**VARIANCE PLAN**

**SOUTH RIVER**  
 LOT 35  
 L.38488, F. 34  
 2691 SOLOMONS ISLAND ROAD  
 EDGEWATER, MD 21037

Re: 2687 Solomons Island Road  
(2024-0025-P)  
Pre-File Explanations

# OFFICE OF PLANNING AND ZONING

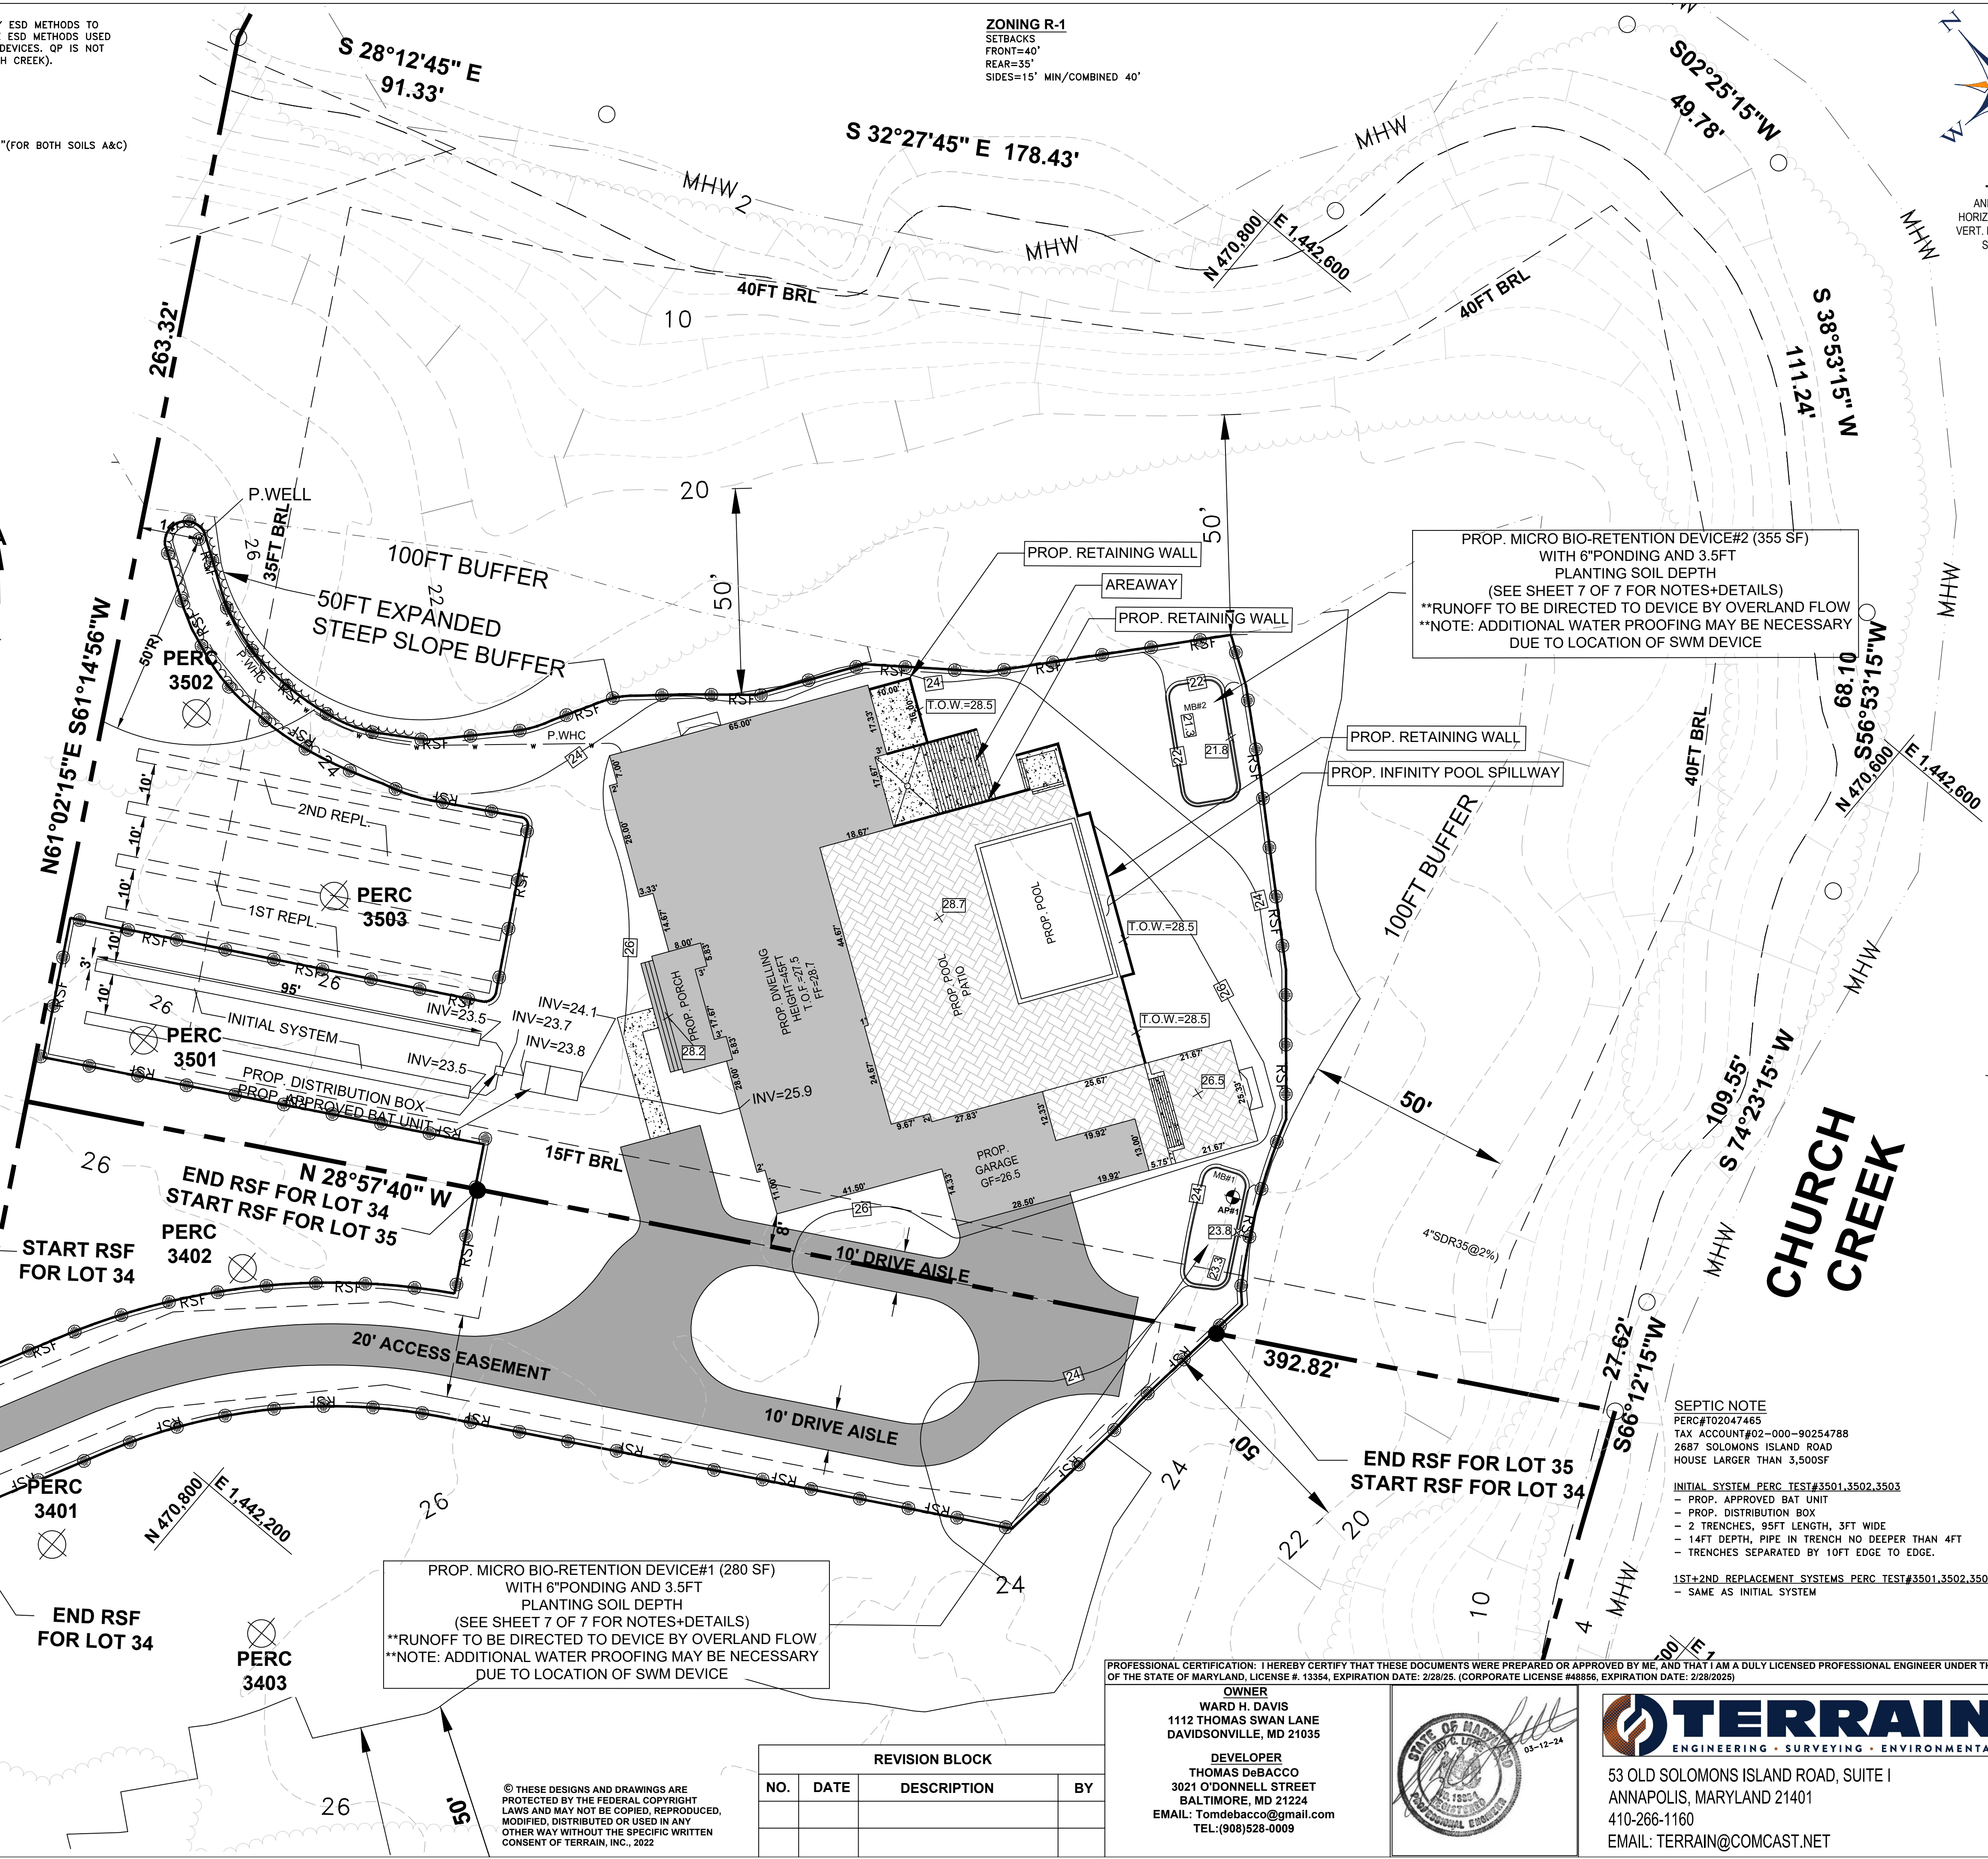
Zoning – Site is addressed 2691 not 2687, zoned R1 not RA as in letter. Side lot line setback variance still required for R1 zone. Plan needs to indicate number of stories. Setback variance preferable to buffer variance.

1. Given the disturbance to sensitive resources (100 feet steep slopes buffer), the proposed design adversely affects the water quality within the Critical Area. Please clarify.
2. Per the proposed design, ESDv is being addressed through two Micro-Bio retention.
3. The Suitability and siting of proposed SWM practices should be reviewed. Soil boring information including verification of the suitability of in-situ soils for infiltration shall be submitted.
4. Based on the plan provided, it appears that the property will be served by a private well and septic.
5. The stormwater management, and utility/Engineering design review approval for the site shall occur at the grading permit stage.
6. The above is provided as courtesy review comments at the pre-file stage to review and consider the design plan; additional reviews and detailed reviews are at the grading permit stage.

We have revised the Plan to reflect the corrected R1 Zoning and Setbacks. The Variance Request has been revised accordingly.

1. We have reviewed the Plan for Disturbance to the 100 ft. Buffer and/or Expanded Buffer. At this time, the Plan as presented does not disturb either Buffer.
2. As noted, ESD is being addressed by two (2) Micro-Bio Retention Devices.
3. There is a Soil Boring on the Plan which identifies the Soils as a Loamy Sand with the minimum Infiltration Rate noted.
4. As noted, the Site is served by Private Well and Septic.
5. It is noted and understood that Final Engineering Design will be Reviewed and Approved during the Grading Permit Process.
6. We believe the Variance Plan addresses all criteria for this stage of Review.
